Mount Clare, Minstead Gardens, Roehampton Gate, London, SW15 4EE

Verification and Critical Analysis Survey Report for
Wandsworth Borough Council
2 December 2025
Our Ref: JP/25-03469

Structural Assessment Report

Figure 7: Sectional floor structure detail produced by the original project architect

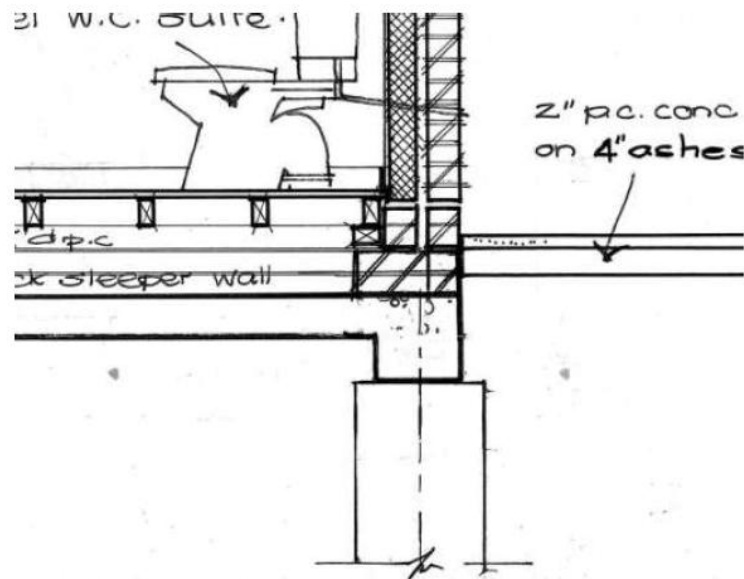
- 5.10 This does not provide any information regarding the thickness, reinforcement or concrete specification for the ground floor slab or foundations. Whether this can be proven to be in compliance with Part A of the Building Regulations remains to be seen. In order for this to be verified, we would expect to see intrusive investigations to be undertaken with structural calculations carried out which can be provided to Building Control for review.
- 5.11 The following sectional detail shows the construction make-up of the original roof structure:
